UNITED STATES PATENT AND TRADEMARK OFFICE

APPLICATION NO.	FILING DATE	FIRST NAMED INVENTOR	ATTORNEY DOCKET NO.	CONFIRMATION NO.
10/748,943	12/29/2003	Neil Keegstra	1122-8	7887
23869	7590	01/23/2006	EXAMINER	
HOFFMANN & BARON, LLP			RADI, JOHN A	
6900 JERICHO TURNPIKE			ART UNIT	
SYOSSET, NY 11791			PAPER NUMBER

Office Action Summary	Application No. 10/748,943	Applicant(s) KEEGSTRA ET AL.	
	Examiner John A. Radi	Art Unit 3641

DETAILED ACTION

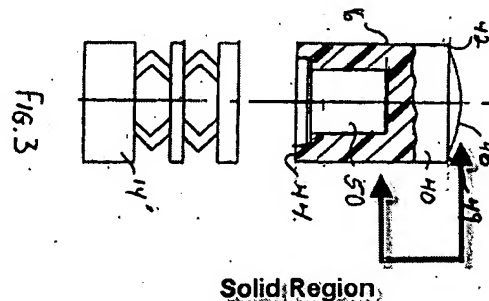
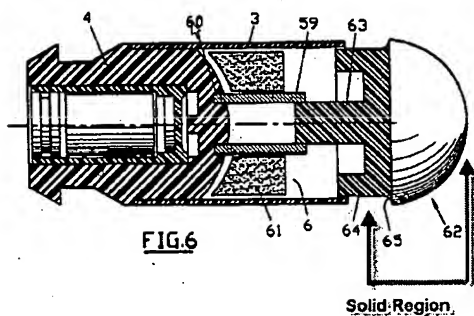
With regard to the argument that Tougeron does not disclose a weight-forward condition, the examiner believes that in Figure 6 it is self-evident that the projectile shifts into a weight-forward situation. When the mass of the nose of the projectile (62) shifts forward, it is inherent that the center of gravity of the projectile moves forward into a weight-forward configuration.

The examiner disagrees with regard to the argument that the nose portion of Tougerons is designed to contain liquid and is therefore not solid. Tougeron's nose portion is solid in the same way that applicant's invention is solid – see applicant's drawings figures 2 and 3 and Tougeron figures 4-6. Examiner defines the nose region of the projectile being from the forward shoulder of the inside cavity (Tougeron: 42, 64) to the tip of the dome.

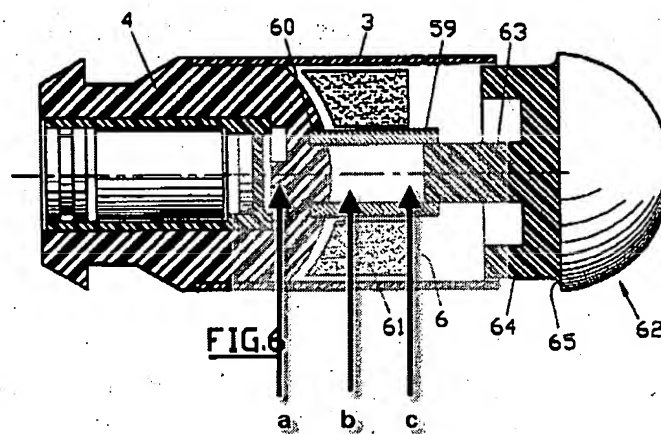
Examiner disagrees that the cavity and motor portions of Tougeron don't bias the weight of the projectile forward. The motor cavity (5) is filled with a propellant and is empty after the projectile is fired, thereby initially moving the center of gravity forward from position "a" to "b." After the nose region of the projectile expands further forward, the center of gravity further moves forward from position "b" to "c."

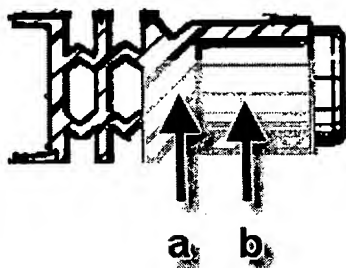
In response to applicant's argument that the hollow region of Knoster is not dome topped or forward weighted, the examiner respectfully disagrees. The projectile disclosed by Knoster includes the unitary pressure wad/seal (12) and the payload (16) which rests inside the hollow cavity. Once fired, the hollow portions of the wad (28) combined with the projectile's mass create a situation in which the projectile is forward weighted (the center of gravity "b" is forward of the geometric center "a").
